Product / Process Change Notification (PCN)	
<input type="checkbox"/> Major change <input checked="" type="checkbox"/> Minor change	
<p>PCN #: PCN_ConFPC_20221226</p> <p>Affected Series: WE-FPC-6861xx18912x; 6871xx18212x</p> <p>PCN Date: September 26, 2022</p> <p>Effective Date: December 26, 2022</p>	<p>Change Category:</p> <input type="checkbox"/> Equipment / Location <input checked="" type="checkbox"/> General Data <input type="checkbox"/> Material <input type="checkbox"/> Process <input type="checkbox"/> Product Design <input type="checkbox"/> Shipping / Packaging <input type="checkbox"/> Supplier <input type="checkbox"/> Software
<p>Contact: Product Management</p> <p>Phone: +49 (0) 7942 - 945 5001</p> <p>Fax: +49 (0) 7942 - 945 5179</p> <p>E-Mail: pcn.eican@we-online.com</p>	<p>Data Sheet Change:</p> <input checked="" type="checkbox"/> Yes <input type="checkbox"/> No <p>Attachment:</p> <input type="checkbox"/> Yes <input checked="" type="checkbox"/> No

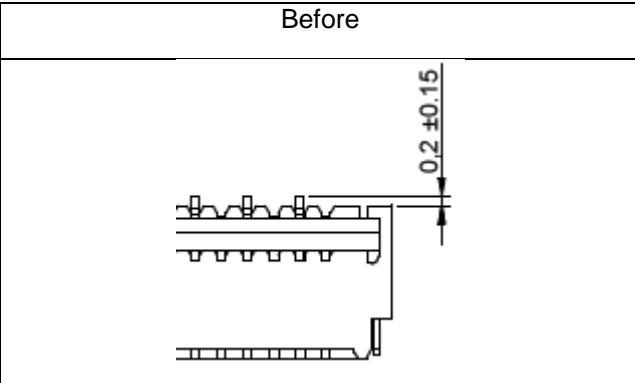
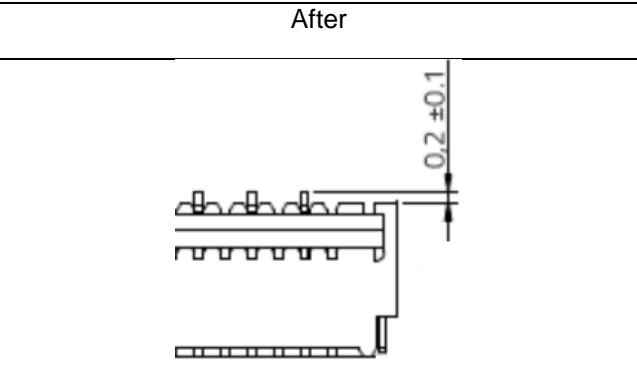
<p>Description and purpose of change:</p> <p>Because of a database mismatch, Würth Elektronik will correct the datasheets. This is a datasheet correction only. There will be no change in form, fit, function, quality or reliability of the product.</p>	
<p>Detail of Change:</p> <p>The pin length will be changed from 0.20mm±0.15mm to 0.20mm ±0.10mm.</p>	
<p>Before</p> 	<p>After</p> 
<p>Reliability / Qualification Summary:</p> <p>There will be no change of the product, therefore no additional reliability or qualification testing will be performed.</p>
